DEPARTMENT OF TRANSPORTATION

49 CFR Part 571

Federal Motor Vehicle Safety Standards; Lamps, Reflective Devices, and Associated Equipment

ACTION: Final rule; response to petitions for reconsideration.

FIGURE 14

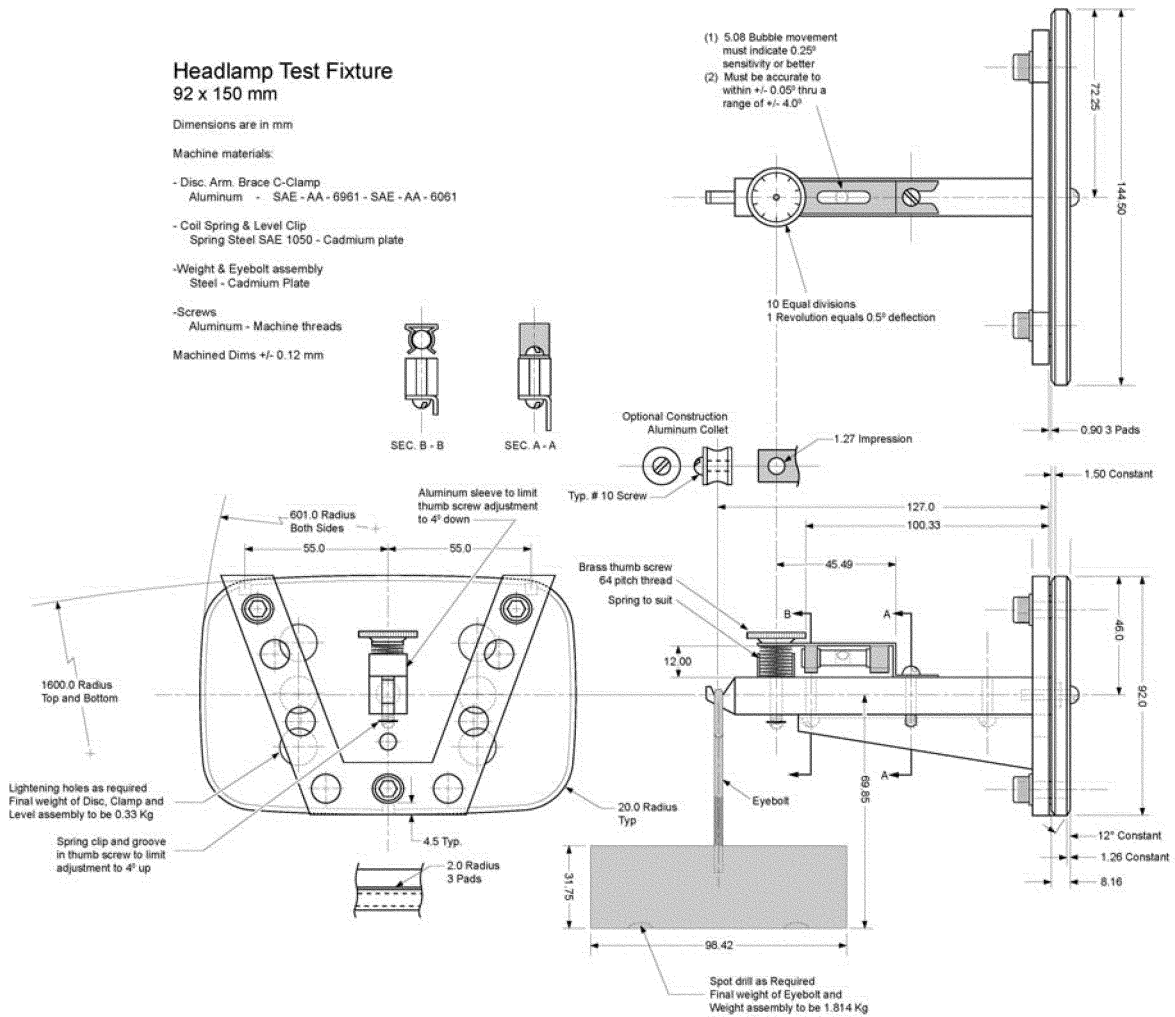
The Associations claimed that the final rule had an error in Figure 8, “Replaceable Light Source Detection Test Setup,” and requested that dimension “A” be replaced with the term “Light Center Length.” The Associations also requested that Figure 14 be changed. They stated that the material specification for the “Disc. arm Brace & Clamp” should appear as “SAE–AA–6061 T6 or equiv,” and the “Coil Spring and Level Clip” should appear as “Spring Steel SAE 1858 –Cadmium Plate.” Also, they stated that in Figure 14, “5.00 Bubble movement” should be replaced by “5.88 Bubble movement” and the screw “Typ. #18” should be “Typ. #10.” Finally, in Figure 14, the Associations suggested that the dimension of “100.33” should instead be “188.33.”

The Associations also requested changes to Figure 14 that include changing the “Disc. Arm and Brace Clamp” material from SAE-AA-6961 to SAE-AA-6061. The agency agrees that this was listed incorrectly and has modified Figure 14 accordingly. They also requested that the “Coil Spring and Level clip” material be changed to “Spring Steel SAE 1858—Cadmium Plate.” The agency does not agree as “Spring Steel SAE 1050” is called out in the currently applicable version of this standard. Therefore, we are denying this request. Also, the agency has corrected the value of the bubble movement to 5.08 and changed the screw number to “TYP #10” in Figure 14 because these changes are consistent with the currently applicable version of the standard. The dimension of 100.33 was correctly translated from the currently applicable version of the standard so the agency is denying the Associations’ request to amend that value to 188.33.
